**1250 AINSWORTH
LOT 3
POWERS POINTE FILING NO. 5**

DRAINAGE LETTER REPORT

PCD File No.
PPR-21-025

May 17, 2021
Project No. 20-290

1250 AINSWORTH ST.
EL PASO COUNTY, CO
EXISTING CONDITIONS DRAINAGE PLAN

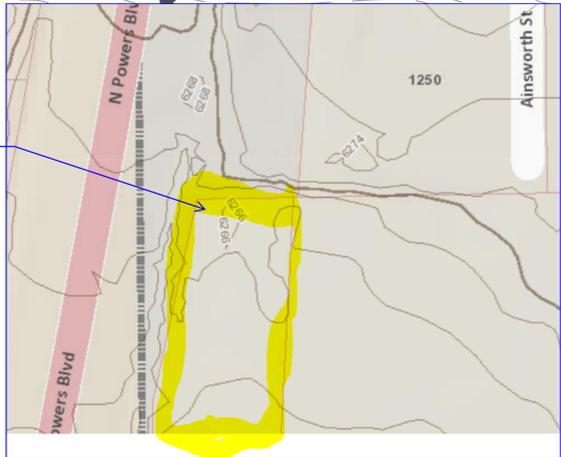
Per the contours it appears runoff in this section does not go into the channel adjacent to Powers, and instead goes into an adjacent lot. Address this in the narrative for existing conditions and change maps to reflect direction of flow.
